Subject: Limerick Generating Station, Units 1 & 2
Request for Additional Information (RAI)
from NRC Instrumentation and Control
Systems Branch

Reference: Letter, A. Schwencer to E. G. Bauer, Jr.
dated August 25, 1982

Transmitted herewith are draft responses and FSAR page changes related to the subject RAIs. This material is provided in draft form at the request of Mr. Virgilio, NRC staff reviewer, in advance of a meeting the week of March 14, 1983. We plan to formally incorporate these responses and page changes into the FSAR subsequent to the March 14 meeting.

GENERAL ELECTRIC		12-50740
REACTOR PROTECTION SYSTEM		
FOR THE LIMERICK 1-E		
OVERALL REVISION	5	
REVISION NO.	1	DATE
2	5	
3	5	
4	5

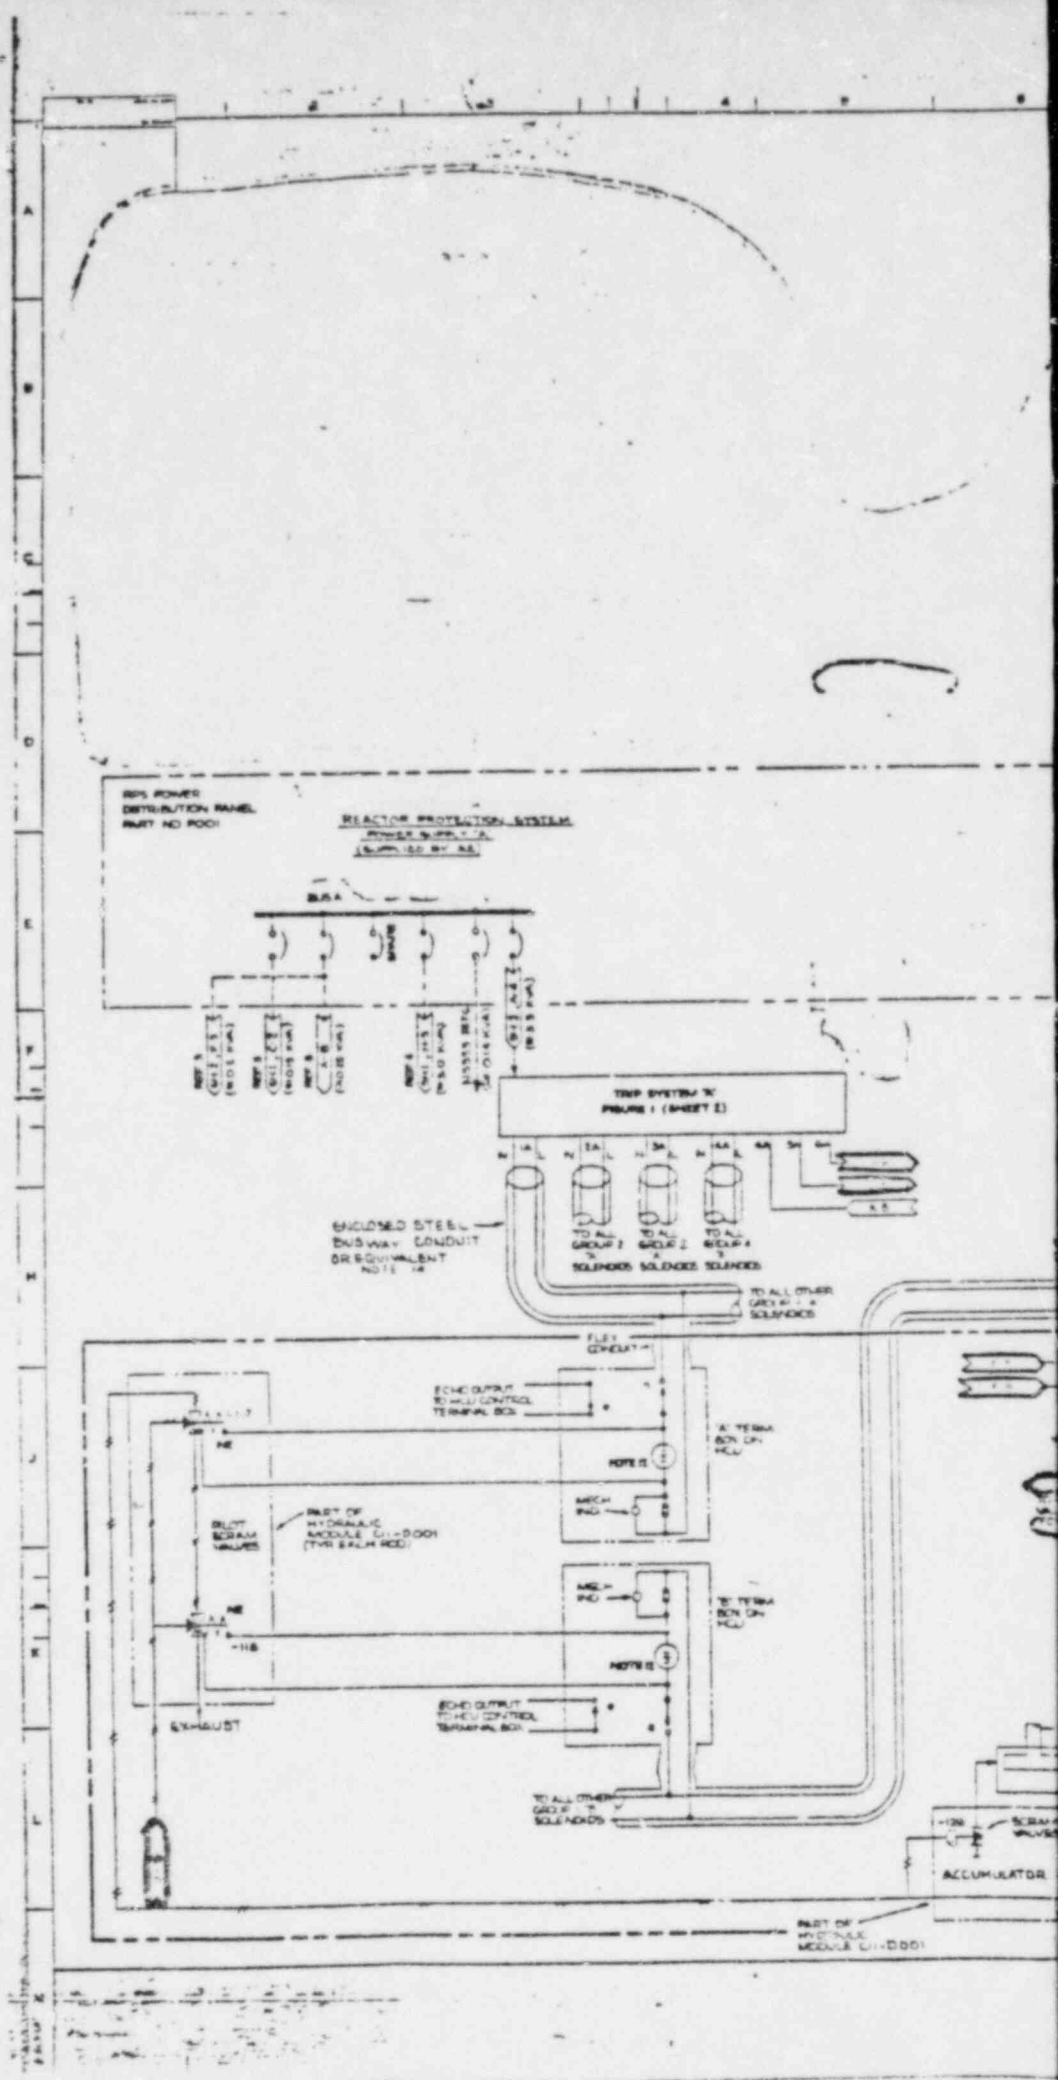
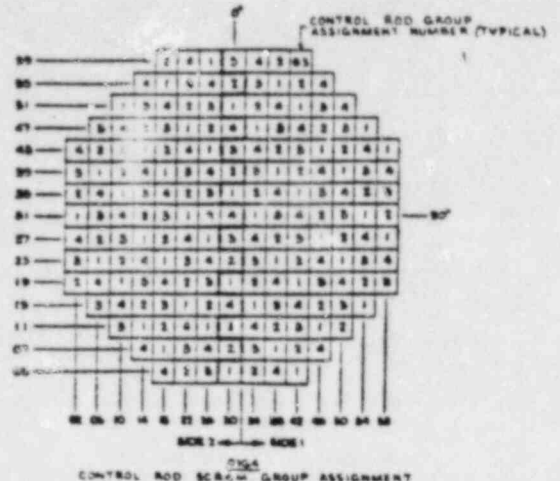
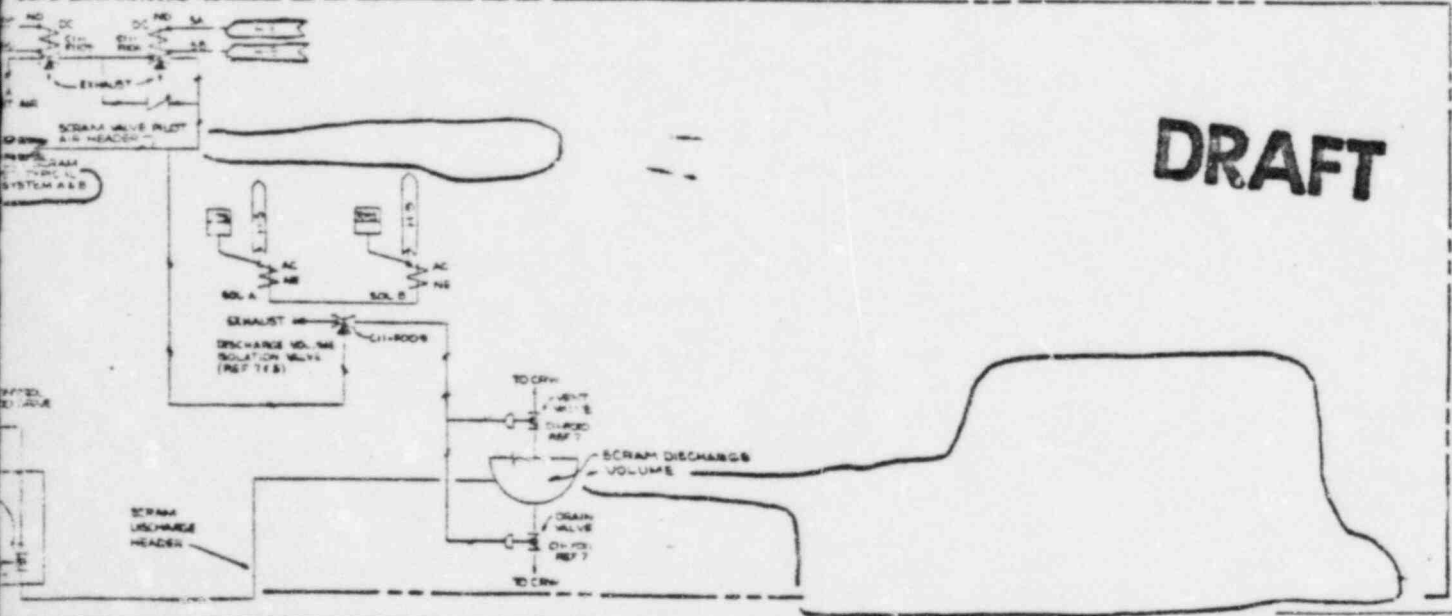
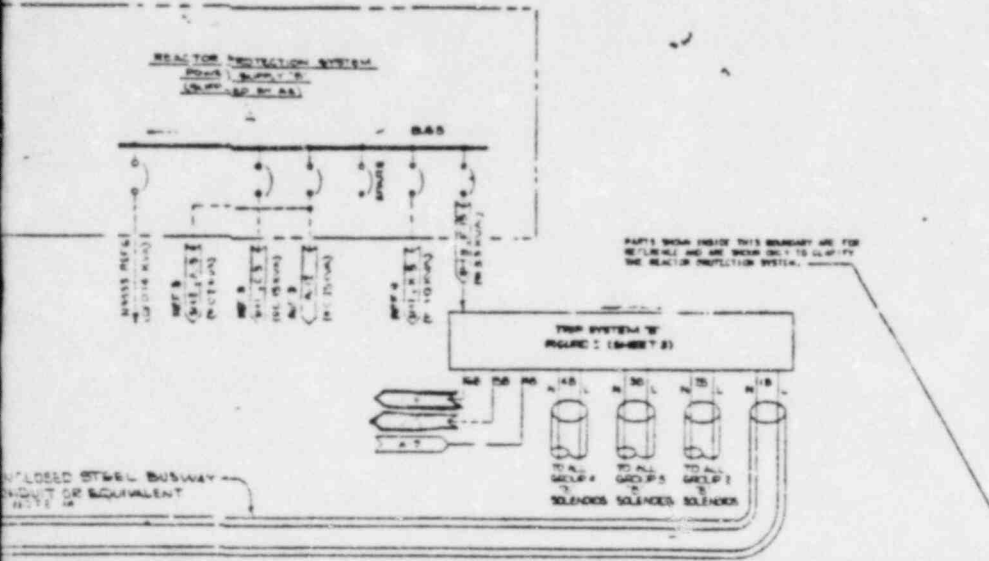
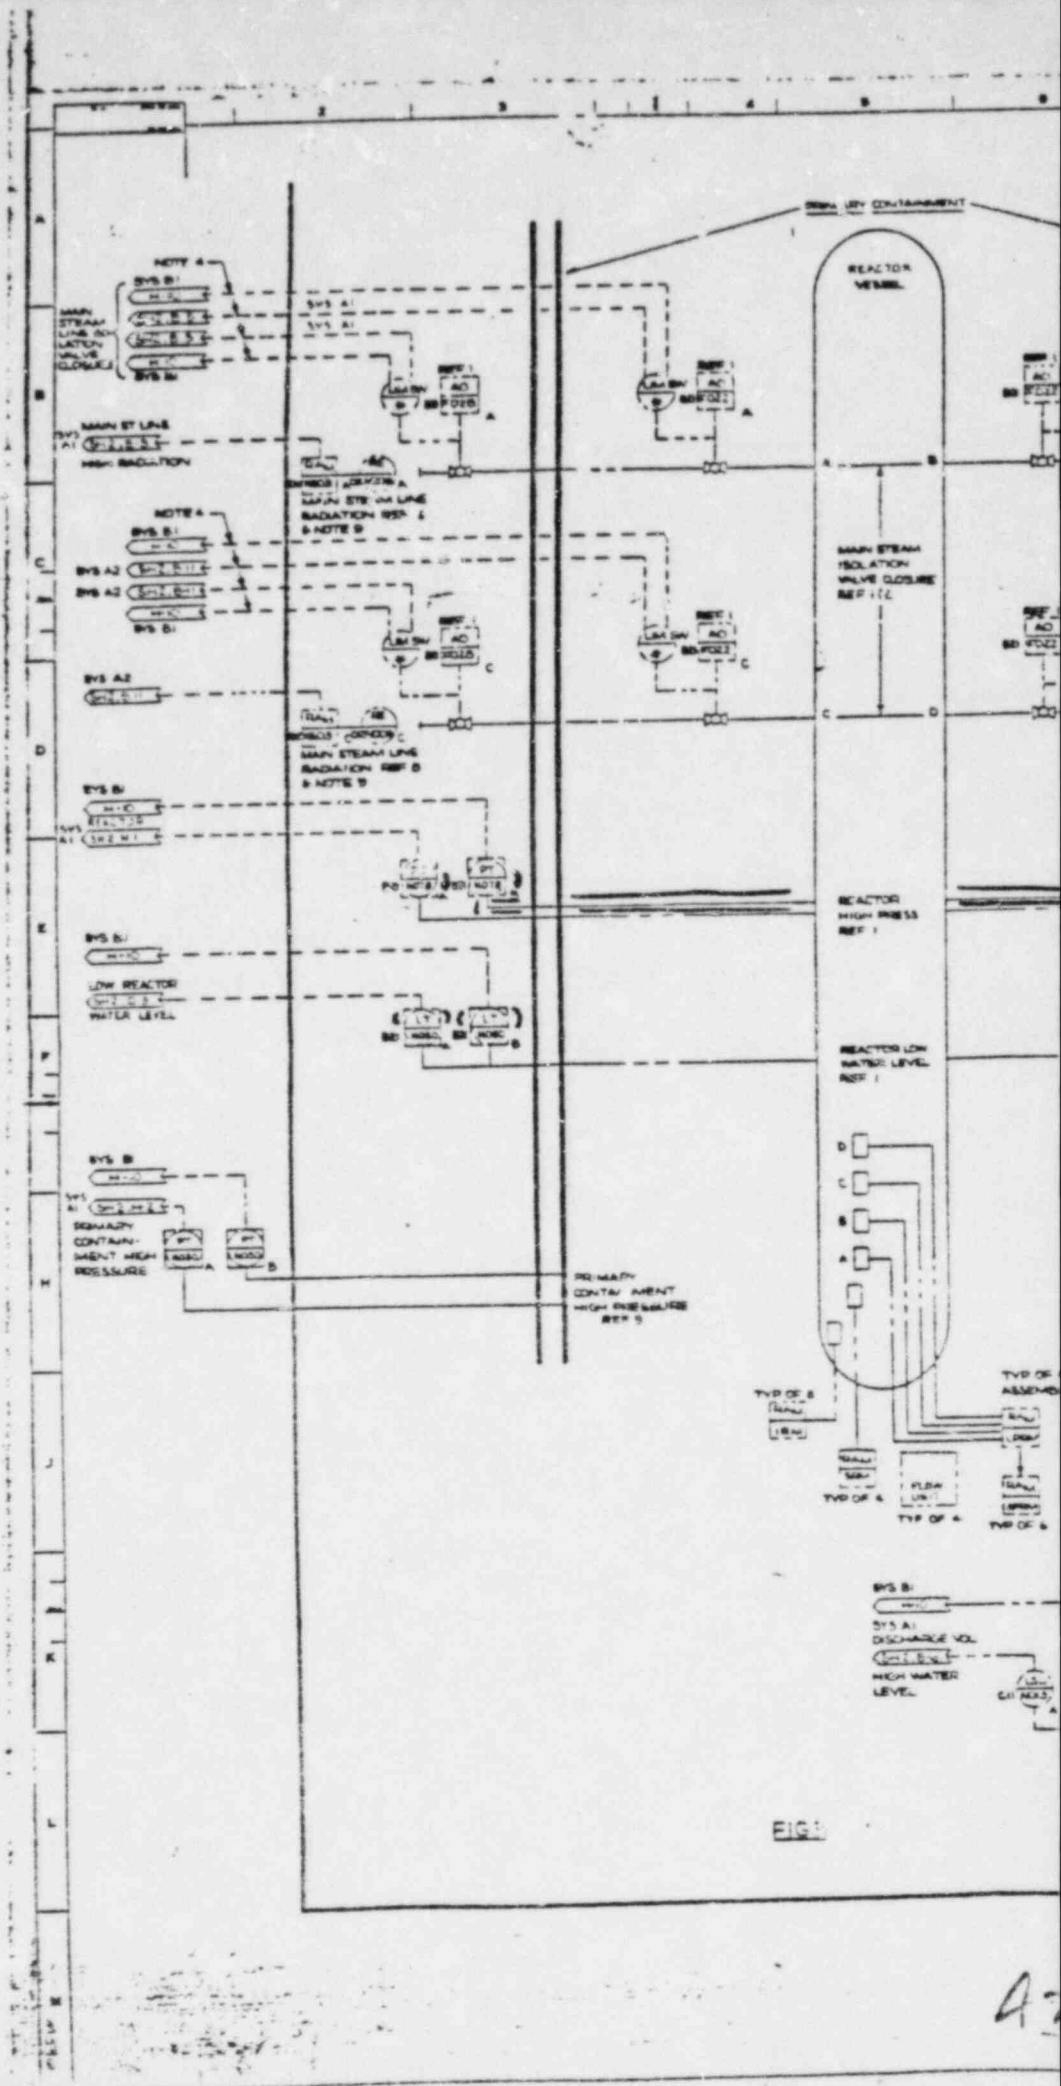
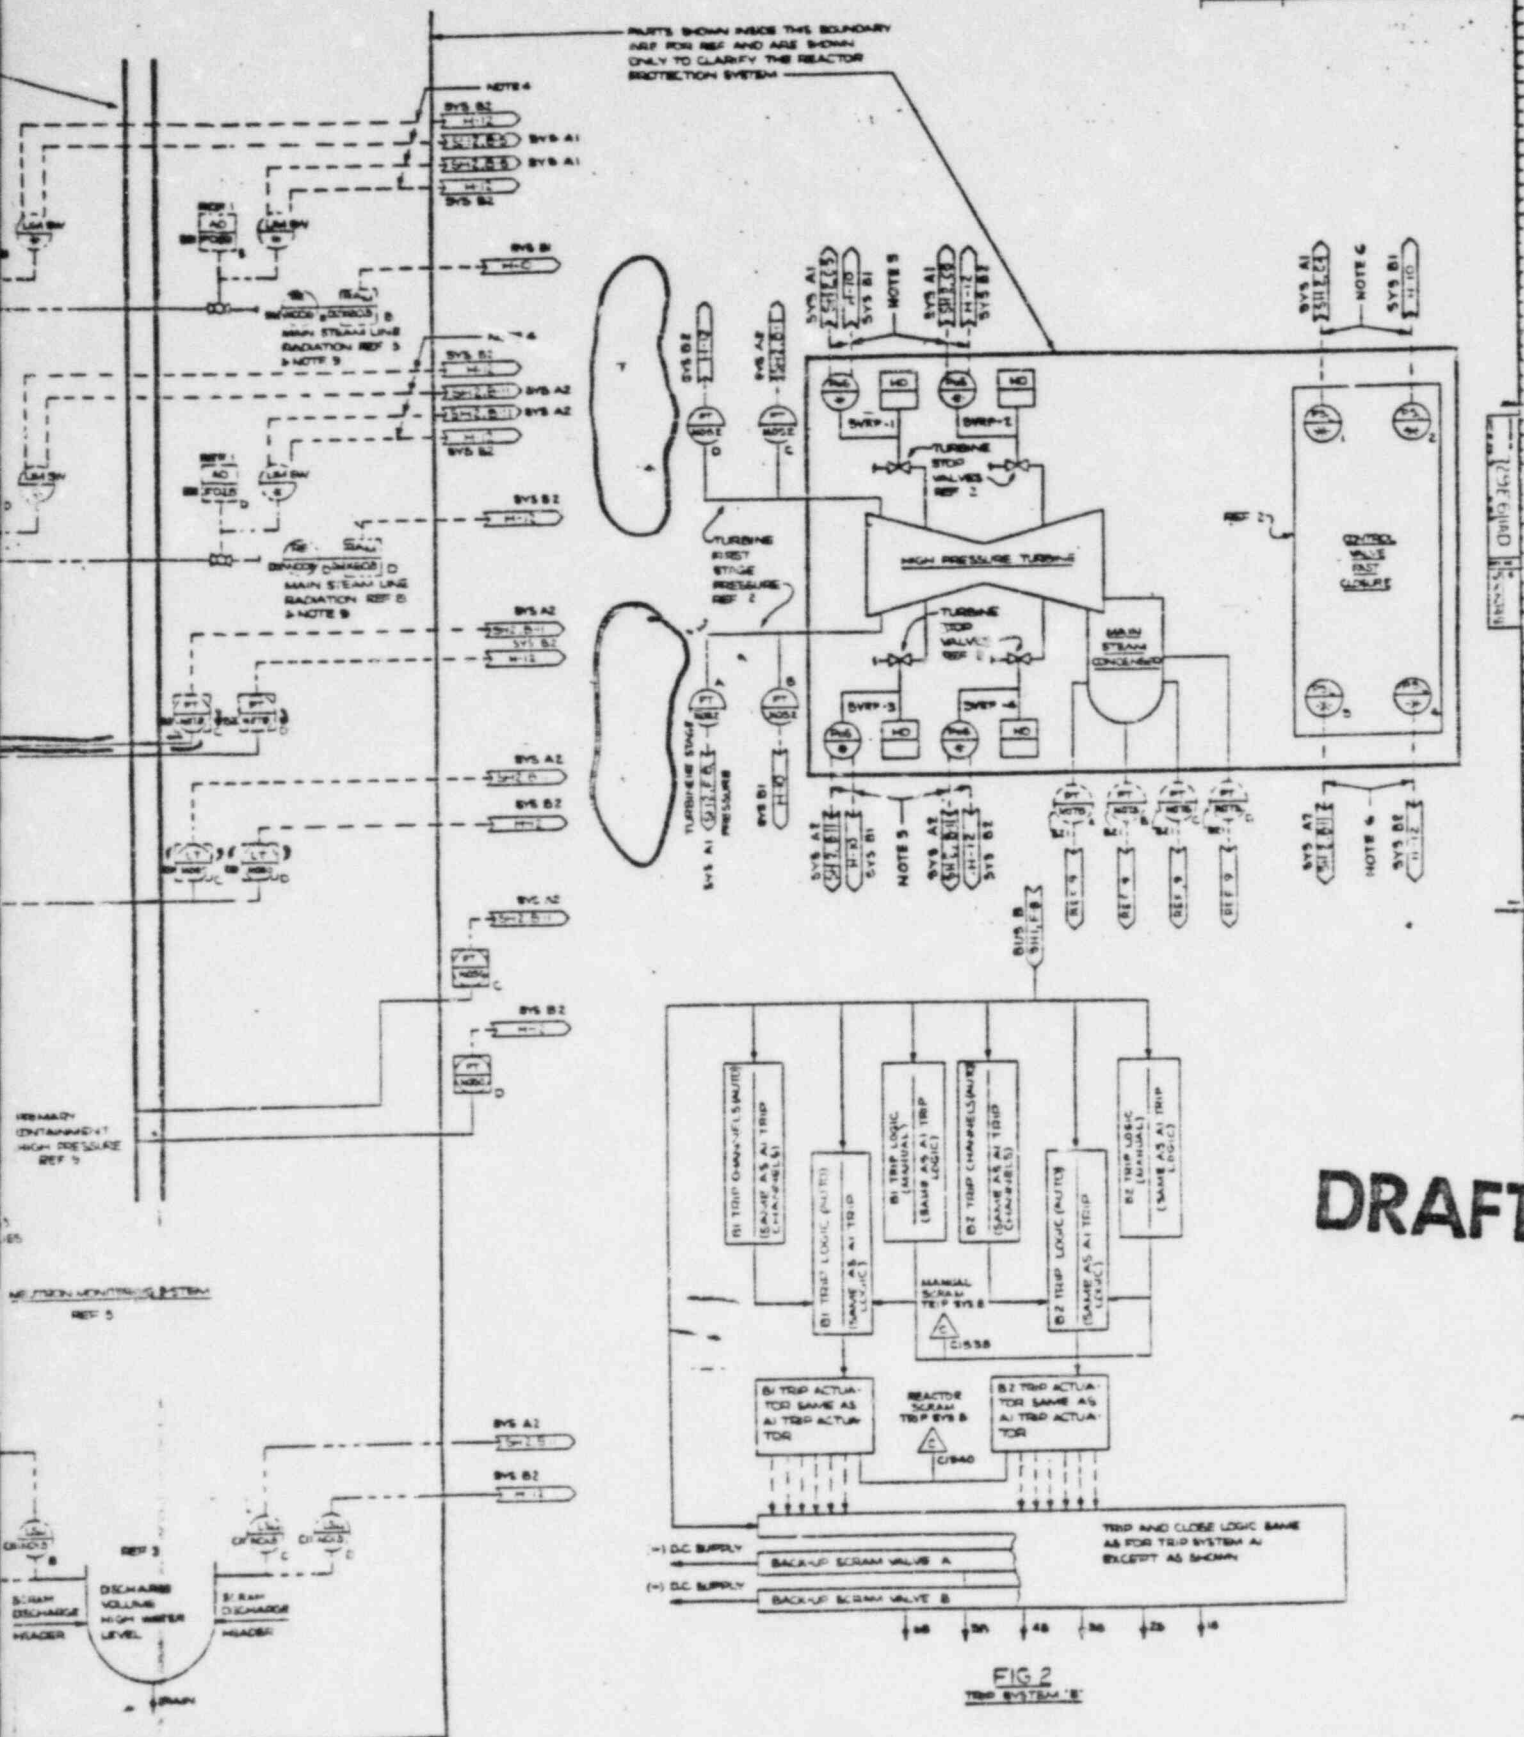
Section 7.2.1.1.4.7 of the FSAR indicates that pilot solenoids for the scram valves "not part of the RPS" and that the RPS interfaces with the pilot solenoids. Discuss the interface area using detailed schematics and drawings as appropriate. Include in the discussion the backup scram valves, their classification and their interaction or interface with the RPS.

The pilot solenoids for the scram valves are part of the hydraulic control unit (C11-D001) of the associated control rod in the control rod drive system.

The function of the pilot scram valve solenoids and the backup scram valves, and their interface with the RPS, are discussed in Sections 7.2.1.1.4.7 and 7.2.1.1.4.8, and detailed in Figure 7.2.1 (sheet 1).

FIGURE 7.7-14

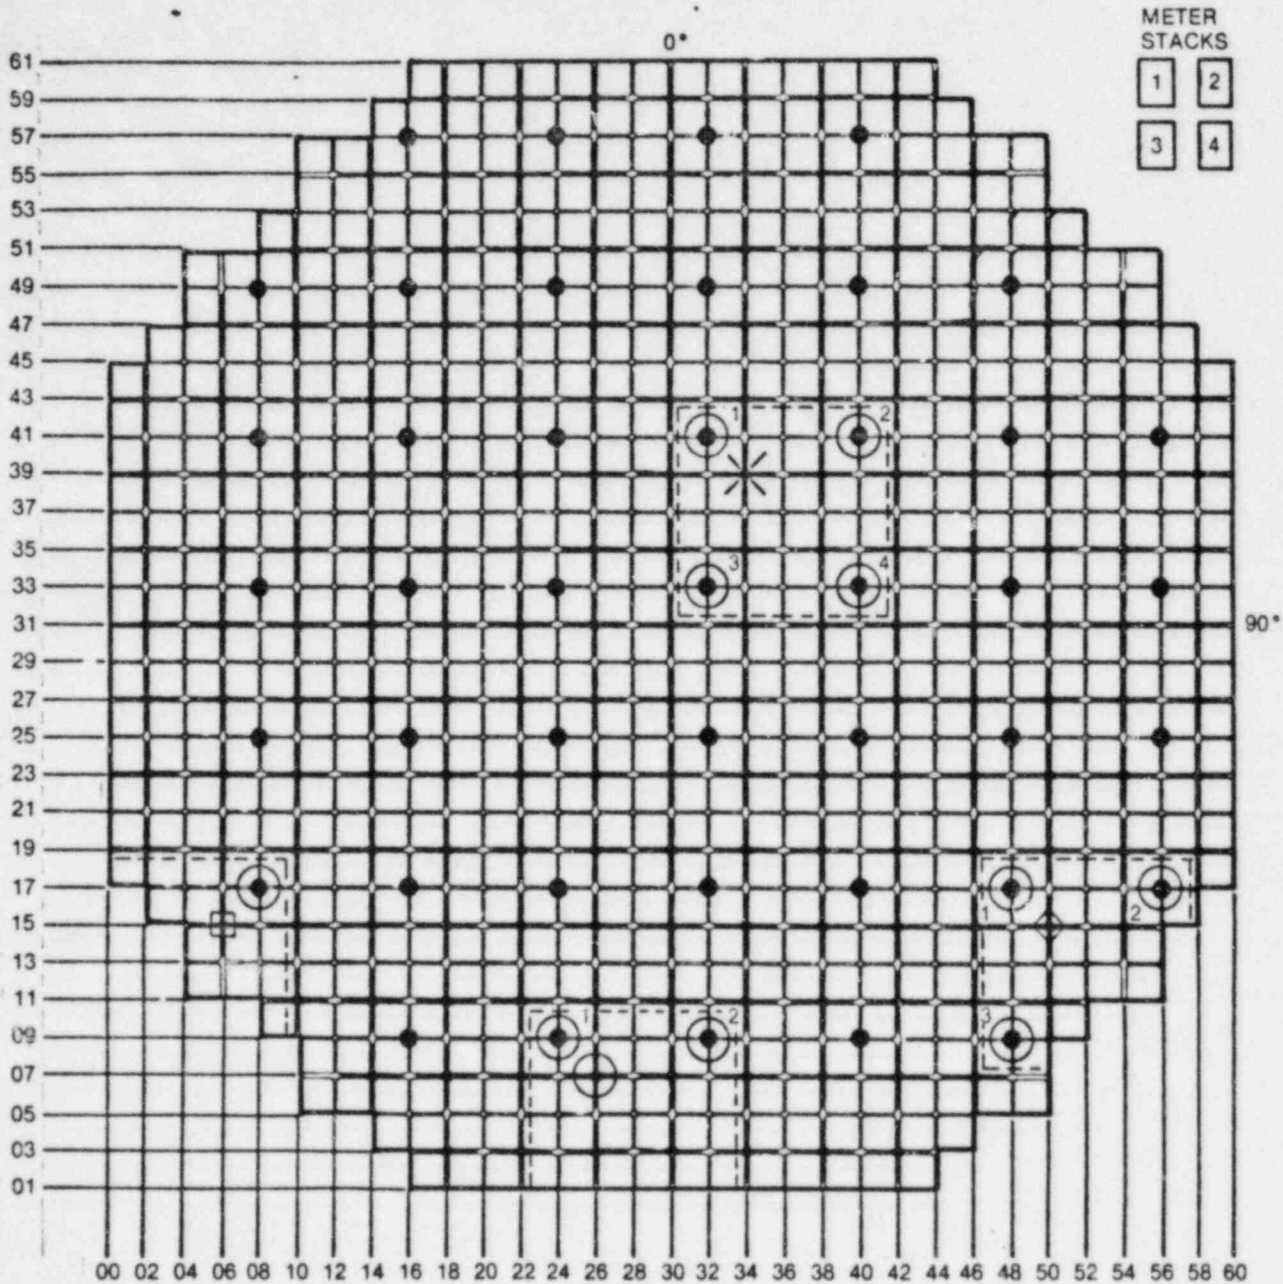
Figure 7.7-14 of the FSAR which provides details of the RBM circuit is not included. It is indicated the information will be provided later. Discuss the status of your design of the RBM and projected availability of Figure 7.7-14.

The RBM design is complete; however, the RBM is considered a subsystem of the NMS system and as such has no RBM unique FCD. The RBM is included in the NMS FCD and is shown in Figure 7.6-4.

Figure 7.7-14 showing the RBM rod selection combinations has been added. Section 7.7.1.6.2.1 has been changed to reference the appropriate figure.
